# Freeway Park Improvements

This is the Seattle Design Commission's (SDC) second review of the Freeway Park Improvements project. The purpose of today's meeting is to review the schematic design phase (60% design phase) for the project. The SDC voted, 7-0, to approve the schematic design phase for the Freeway Park Improvements project with several recommendations.

**March 4, 2021**

Schematic Design

Figure 3: Wayfinding and signage types

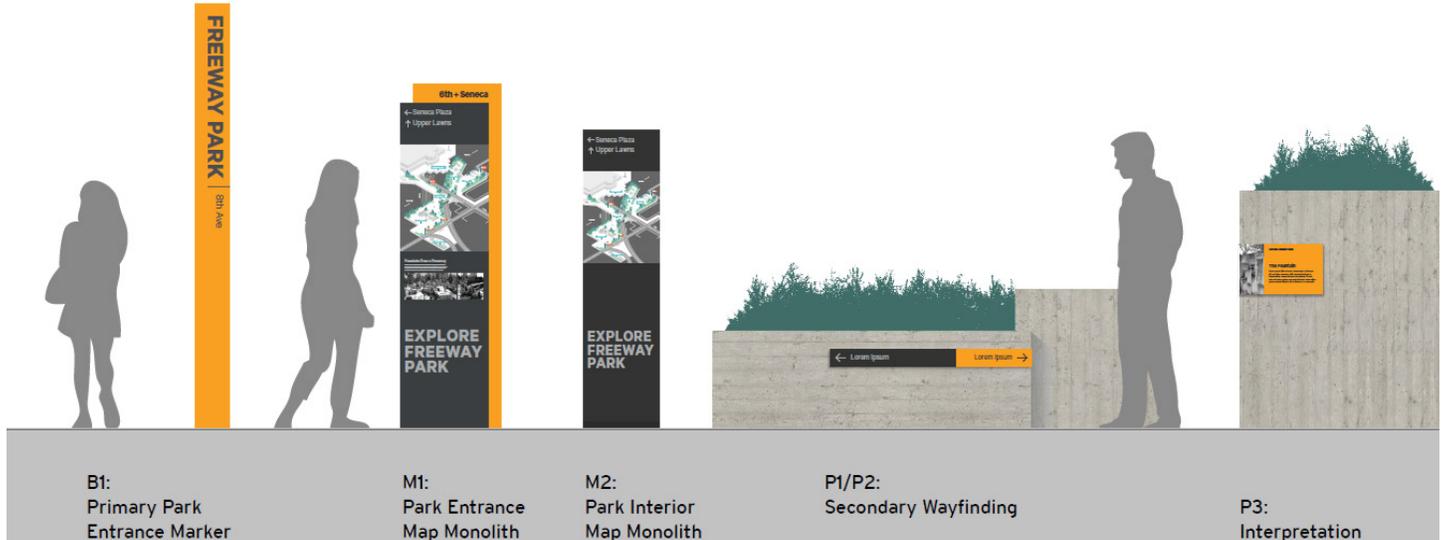
The Commission appreciated the wayfinding proposal. Specifically, Commissioners appreciated the design of the maps. The Commission commended the project team for their use of sign prototypes to better understand if the location and design of each sign type worked well within the surrounding site context. The Commission also appreciated the use of color, which will provide a contrast to the cool color palette of the park. Commissioners recommended the project team consider a hierarchical approach when deciding where it is and is not appropriate to use color.

Figure 4: Design proposal of new bench seating (top), new plinth seating (bottom left), refurbished bench seating (bottom right)  
 March 4, 2021

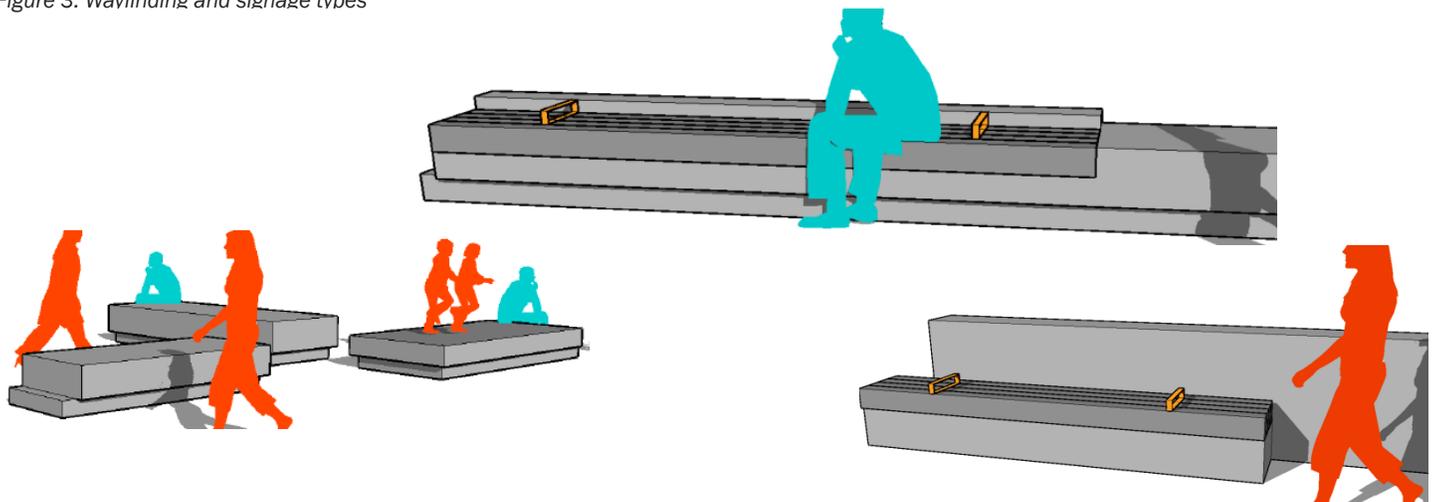
Commissioners then discussed details related to the lighting and seating elements. The Commission appreciated the project team's approach to lighting beneath the 8th Ave underpass. Commissioners commented that the proposal was a creative opportunity to provide an art element while also addressing personal safety. The Commissioners then commented that the existing seating grips have a strong visual presence and encouraged the project team to consider this as they continue to develop the design proposal for new seating grips.
